Revision No. 1 for Addendum No. 1

PROJECT NO. SL 113-5-1

MINE DRAINAGE POLLUTION ABATEMENT  
COAL RUN  
SHAMOKIN CREEK WATERSHED  
NORTHUMBERLAND COUNTY, PA.

RIPRAP ENTRANCE AND  
OUTLET DETAILS

CONCRETE PIPE  
NOT TO SCALE

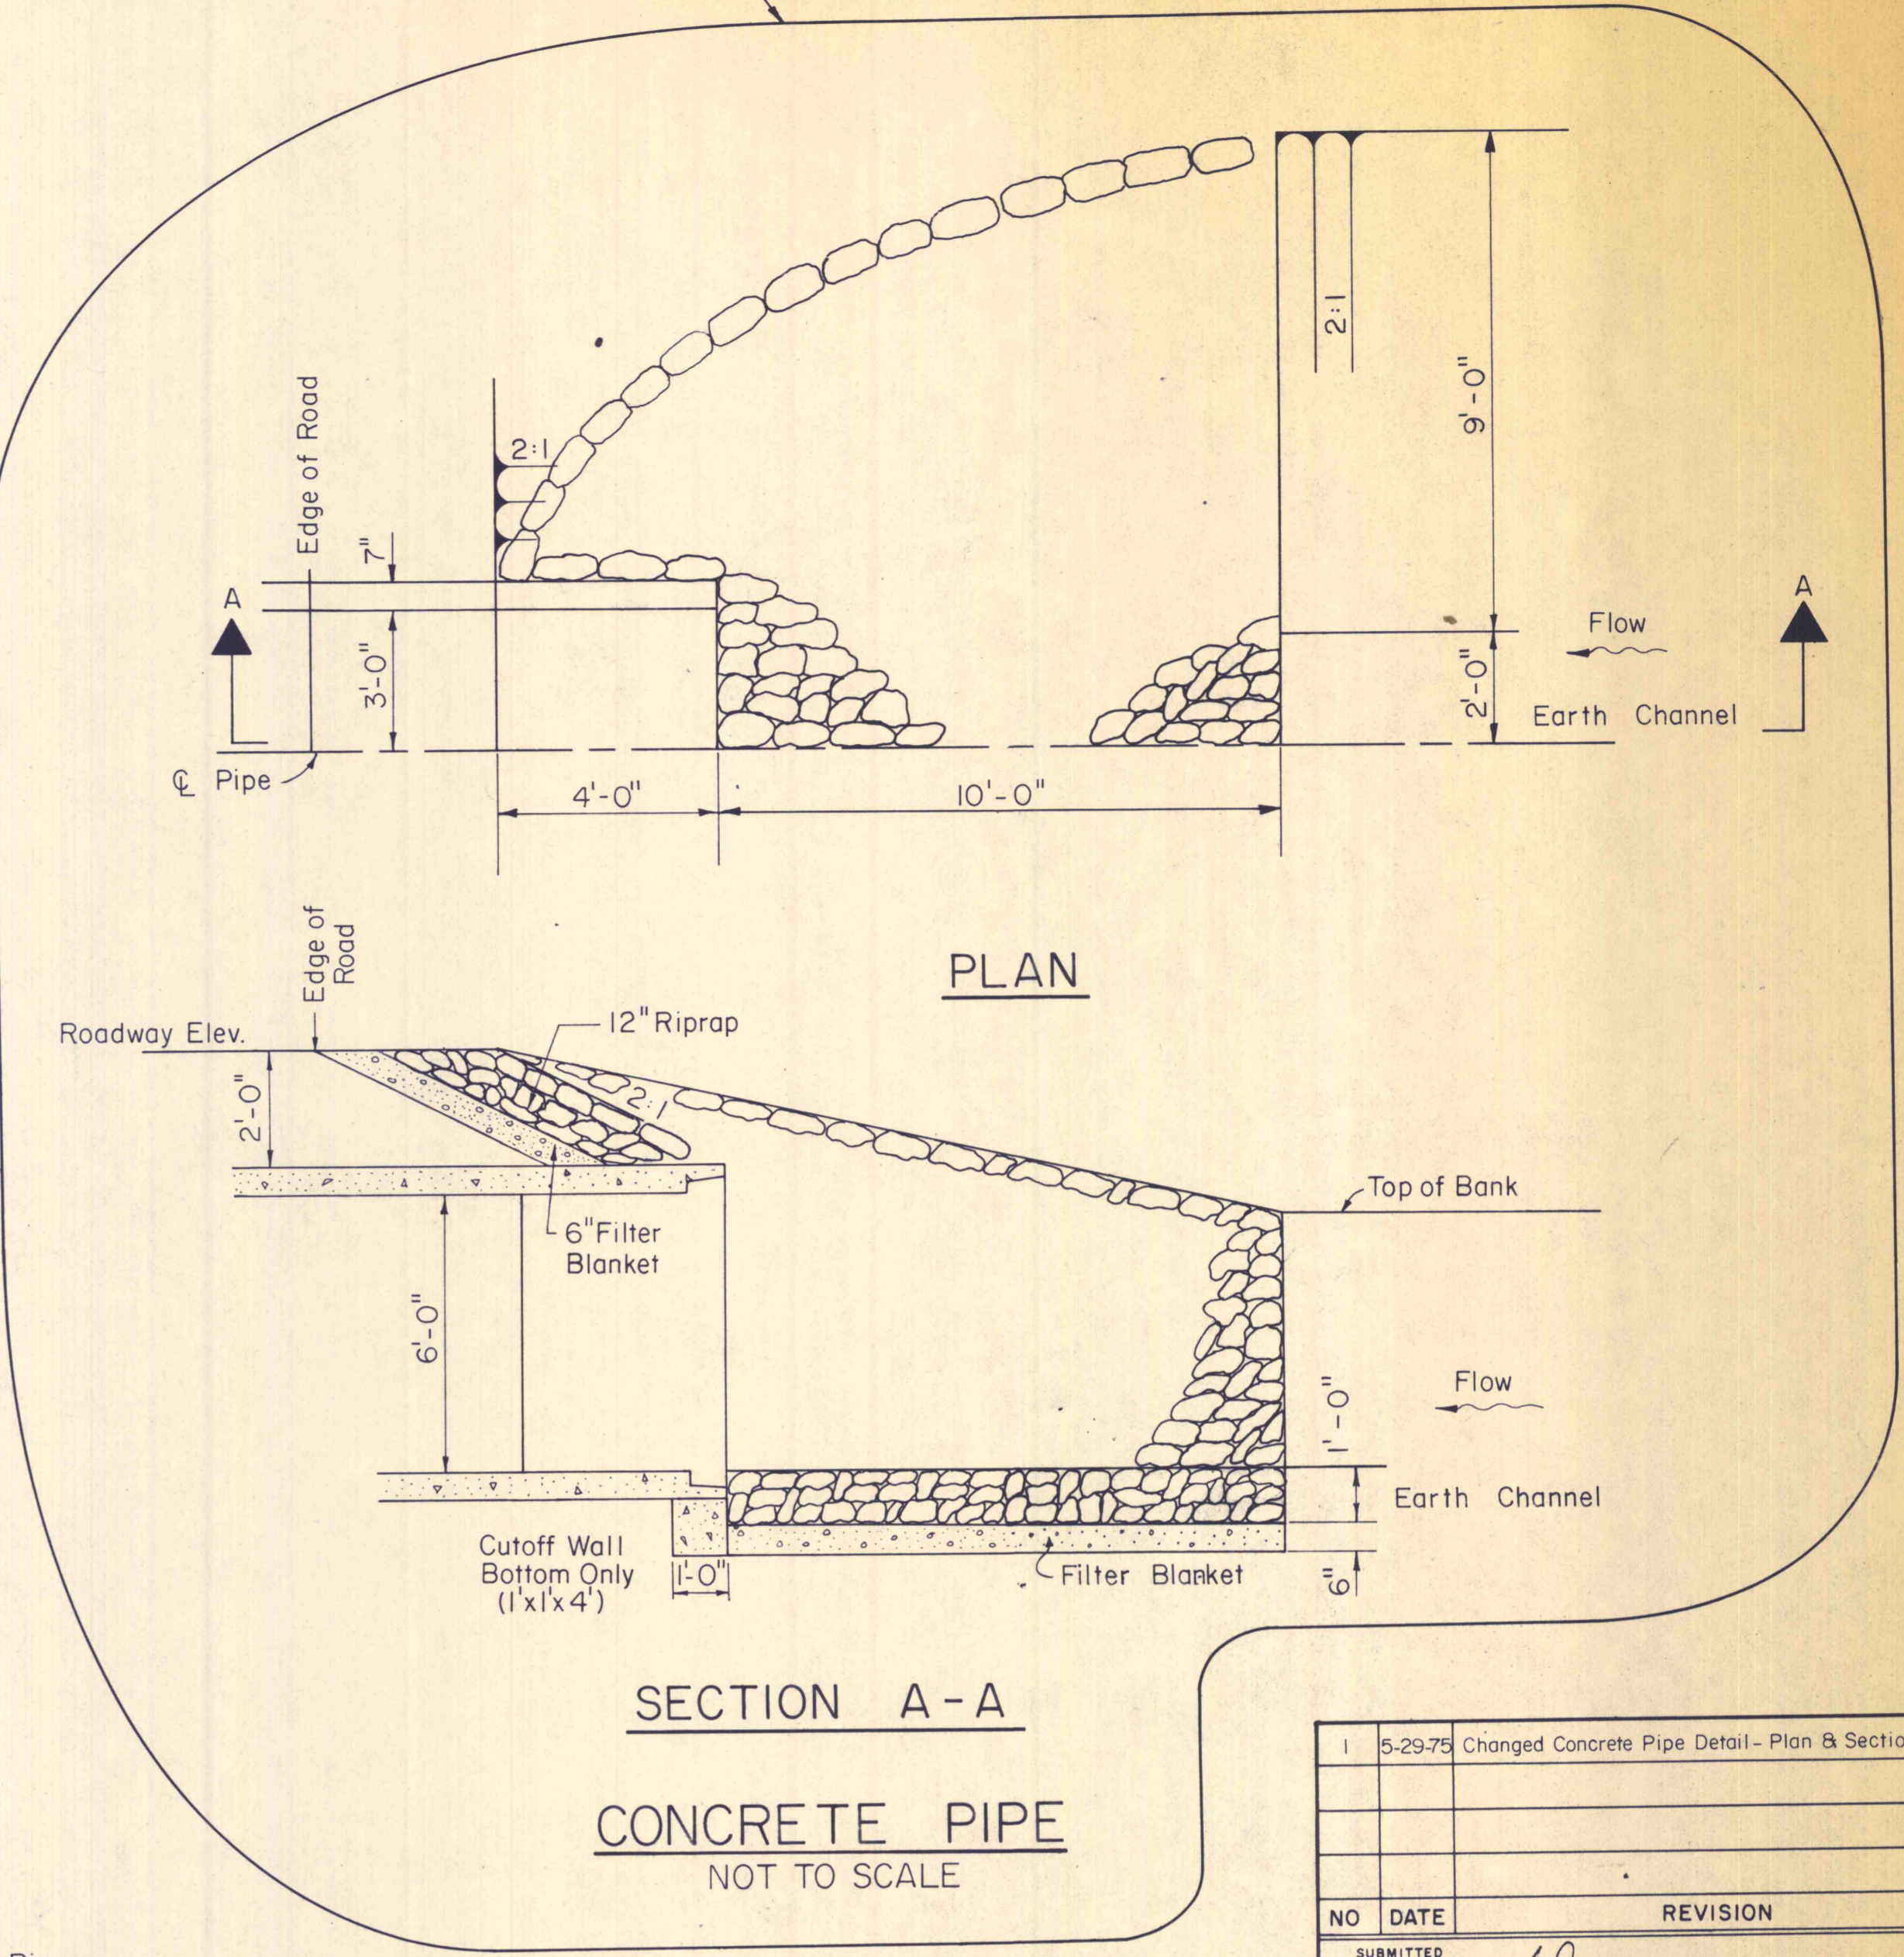
1	5-29-75	Changed Concrete Pipe Detail - Plan & Section	RMZ
NO	DATE	REVISION	APPR.
SUBMITTED			
<i>Richard B. Ulp</i> PROFESSIONAL			
APPROVED			
<i>Robert A. Pomeroy</i> CHIEF - DIVISION OF MINE RECLAMATION			
APPROVED			
<i>Robert A. Pomeroy</i> DIRECTOR - BUREAU OF DESIGN
